PROJECT CONCEPT REPORT

Bethany Road (CR 61) at Providence Road (CR 27)

Project Number: HPP-0000-00(531)

To: Chris Kingsbury FTC
From: Carson Spencer USI *CS*
cc: Antonio Valenzuela Fulton County Chris Woods GDOT
Scott Lee GDOT Scott Zehngraff GDOT
Zanda Montgomery GDOT Ken Werho GDOT
Harry Graham GDOT Michael Coleman GDOT
Wayne Gault USI Carol Bowler FTC
Date: 5/17/06
Re: Bethany Road At Providence Road Intersection Improvements (T150) – Initial Concept Team Meeting Minutes: 5/17/06

...ConceptReport\Typical.dgn 8/30/2008 8:34:00 AM

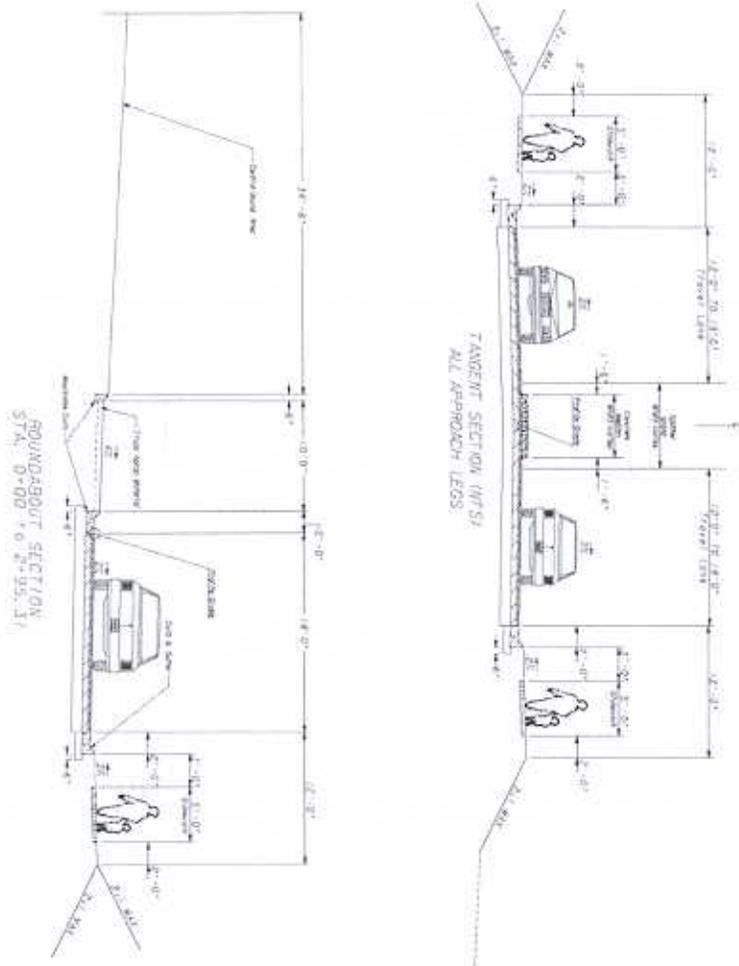
- 1) Adjust the roundabout typical section to show the FHWA recommended 2" mountable curb as appropriate
- 2) Remove the note on the roundabout typical section indicating a mountable curb at the inside of the truck apron adjacent to the center of the roundabout island
